HOPE CREEK GENERATING STATION  
DOCKET NO. 50-354  
FSAR COMMITMENT STATUS THROUGH AUGUST 1984

ATTACHMENT I  
HOPE CREEK GENERATING STATION  
FSAR COMMITMENT STATUS THROUGH AUGUST 1984

QUESTION 220.21 (SECTION 3.7.2)

FIGURE 210.21-16  
 RESPONSE SPECTRA COMPARISON,  
 UNIT 1 REACTOR BUILDING AT ELEV. 54' -0",  
 VERTICAL, OBE, 2% DAMPING

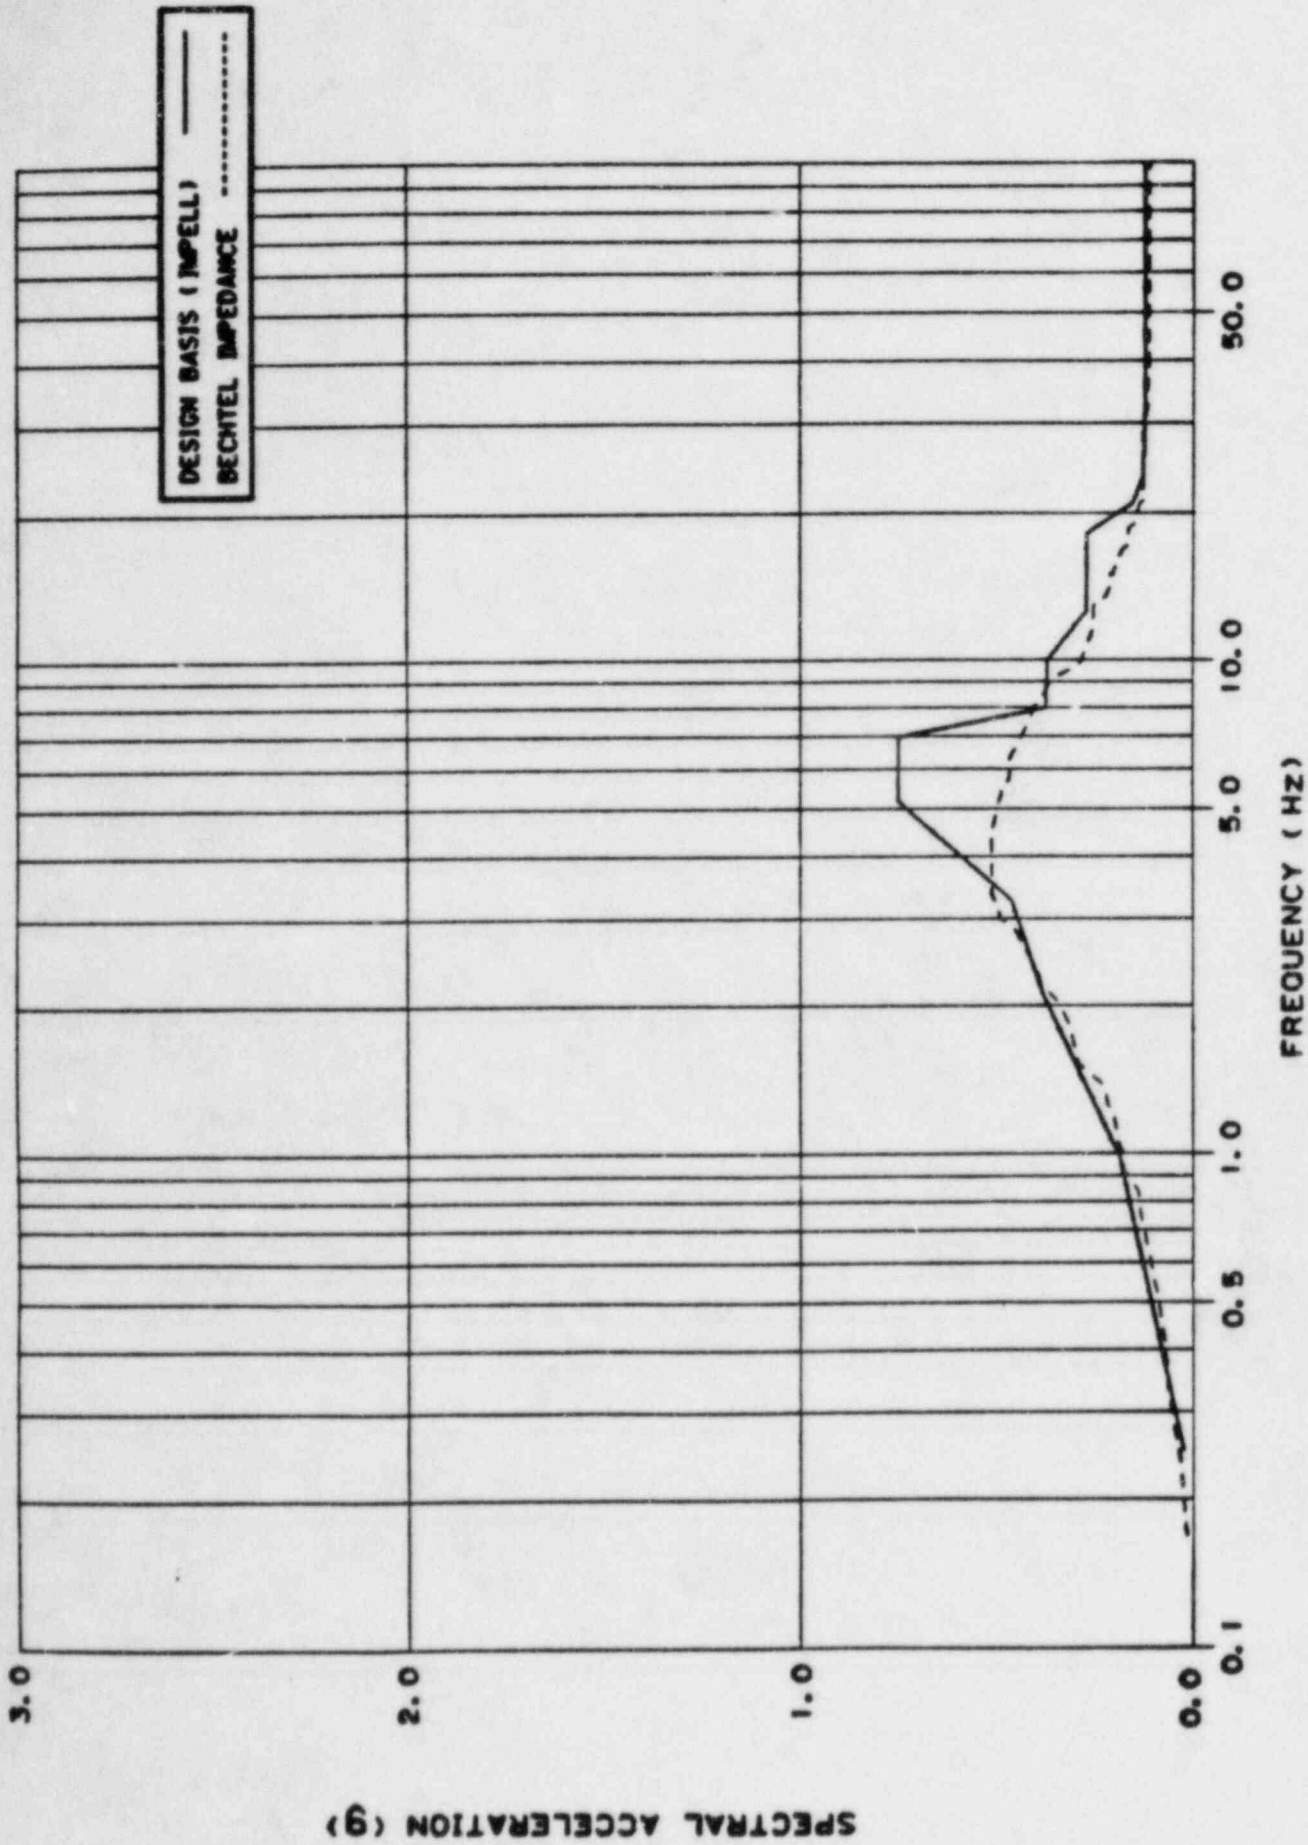
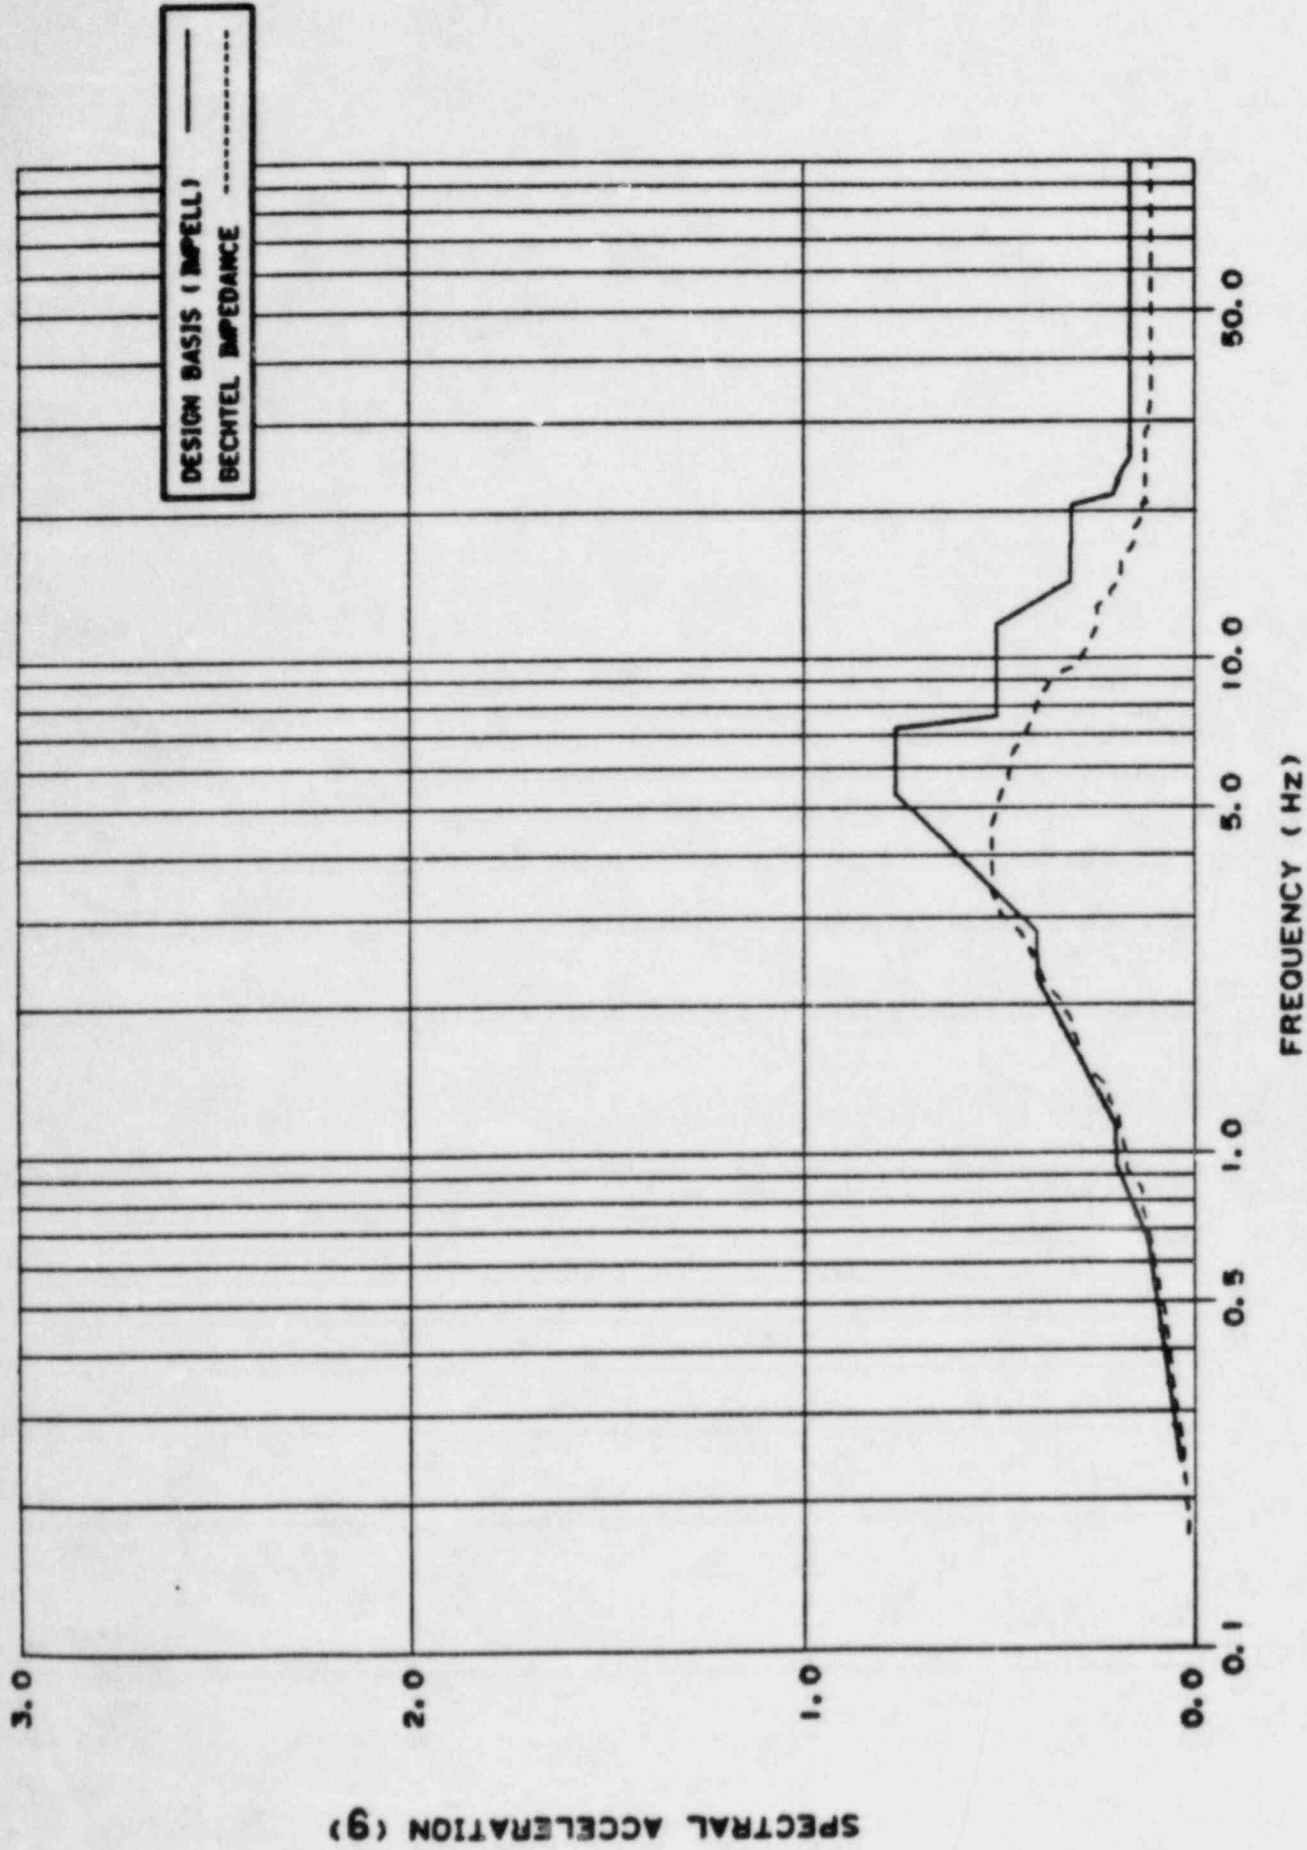
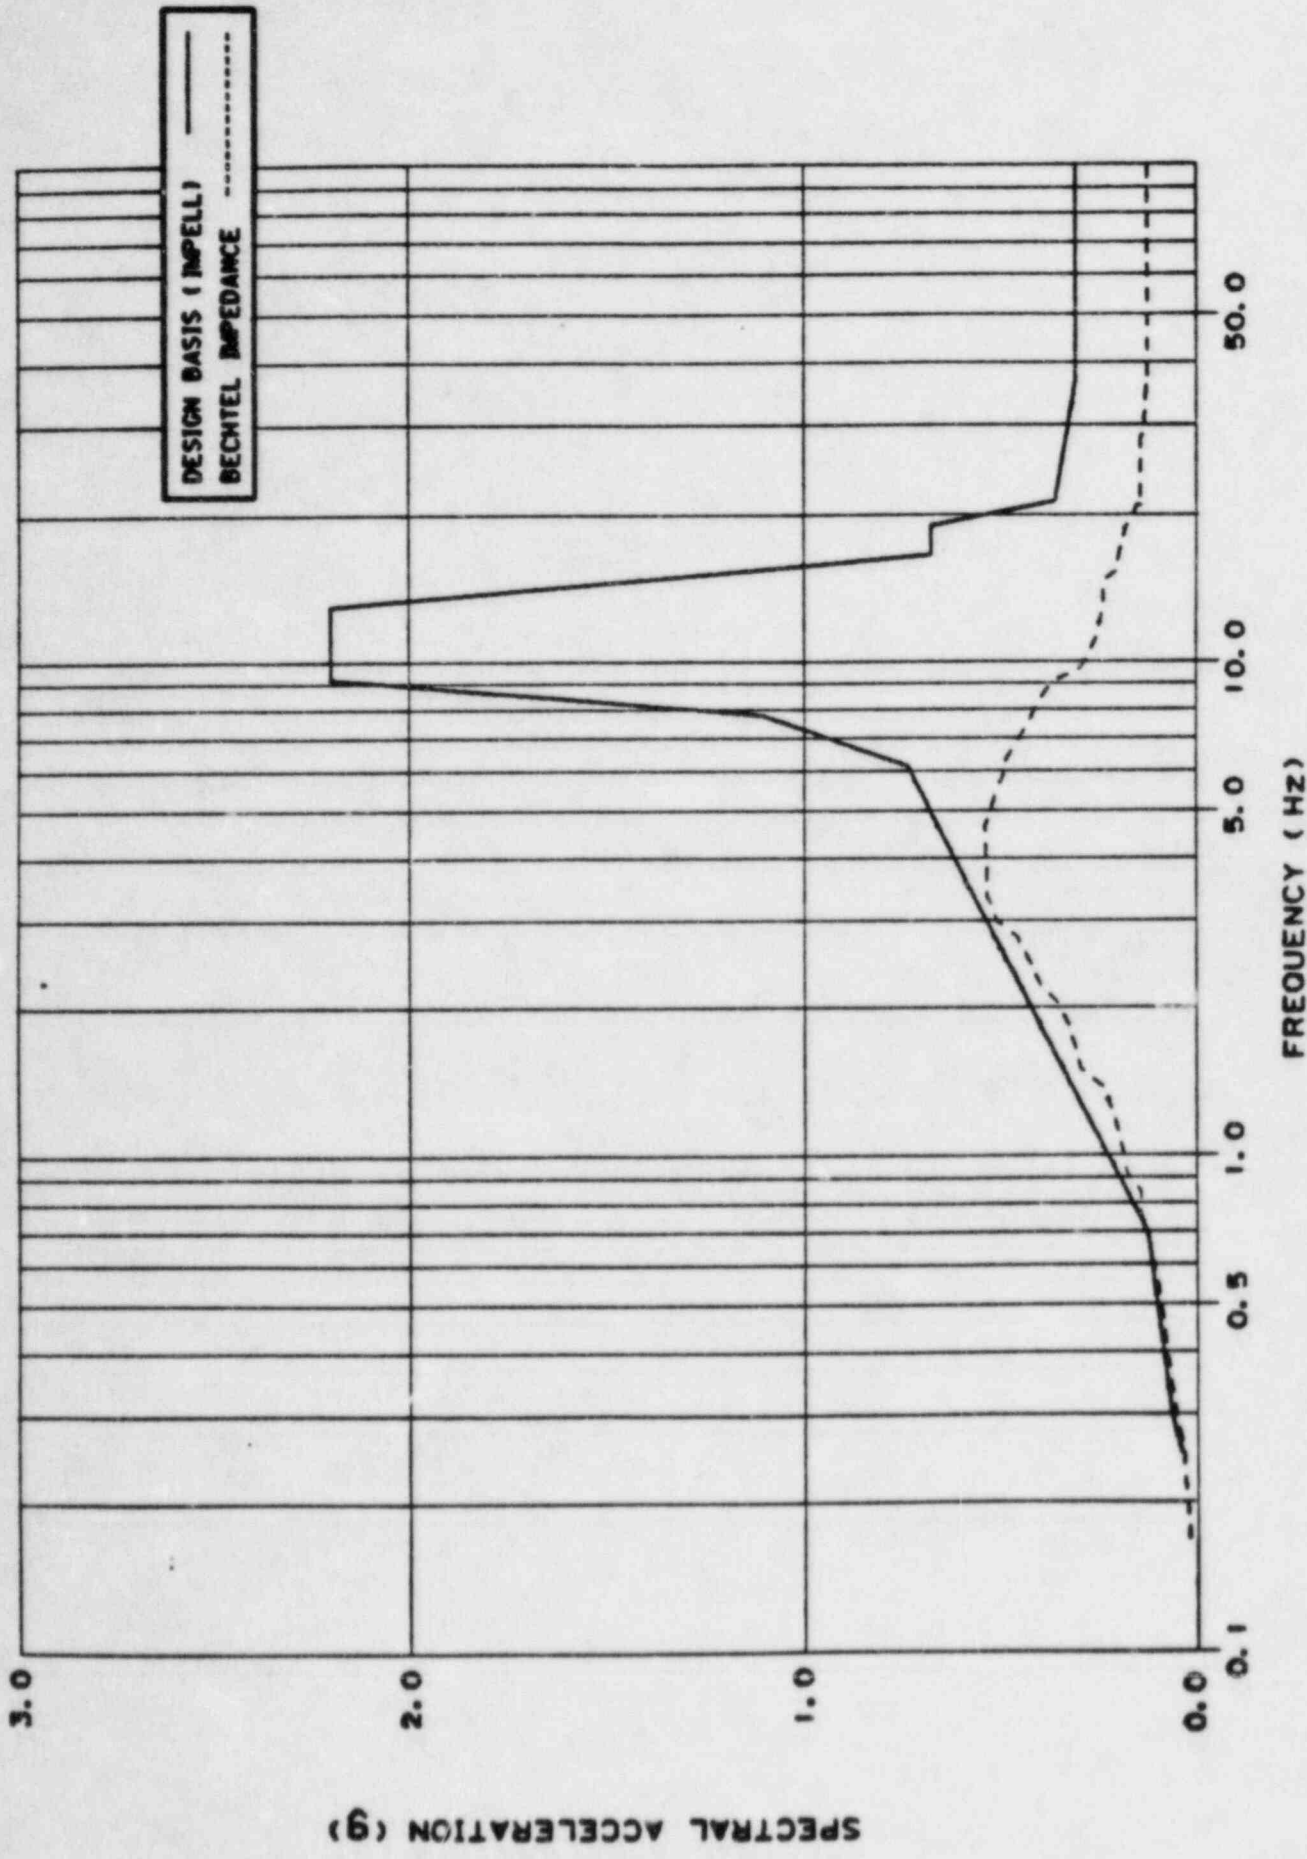
The Hope Creek soil-structure interaction analysis is performed by applying a specified earthquake input motion at the base of the finite-element model. The base level input motion is generated through a deconvolution analysis. The applicable SRP criteria for soil-structure interaction analysis require that both the half-space and finite-element approaches should be considered. (For details refer to SRP 3.7.2-11.4). Public Service should perform necessary analyses to demonstrate conformance to the criteria.

Figures 220.21-1 through 220.21-54 show a comparison of the 2 percent damping response spectra obtained from the design basis finite element and the impedance analyses for the reactor building, auxiliary building and the service water intake structure (SWIS).

¶ For the reactor and auxiliary buildings, the peak spectral accelerations obtained from the impedance analysis are generally lower than those obtained from the design basis analysis. However, the impedance analysis response spectra are not completely enveloped by those obtained from the design basis analysis, especially in the frequency range from 1.0 to 3.5 Hz. Also, there are some local exceedances in the higher frequency range, as shown in Figures 220.21-1 through 220.21-36. ¶ For the SWIS (Figures 220.21-37 through 220.21-54), the impedance analysis response spectra are generally enveloped by those obtained from the design basis analysis at elevation 114.0 feet. For other elevations, the impedance analysis spectral accelerations exceed the design basis spectral accelerations in some frequency ranges. These ranges vary approximately between 1.5 and 10.0 Hz.

forces and moments obtained from the impedance analysis exceeded the design basis values at various locations within these buildings. The auxiliary building seismic shear forces and moments obtained from the impedance analysis are less than the design basis shears and moments.

Since the impedance analysis results are not completely enveloped by the design basis finite element analysis results, sampling studies are conducted to confirm the adequacy of the plant design. These sampling studies include an evaluation of the following items:

In all cases, the items reviewed during these sampling studies can accommodate the loads resulting from the impedance analysis. Therefore, the impedance analysis results have no impact on the plant design.
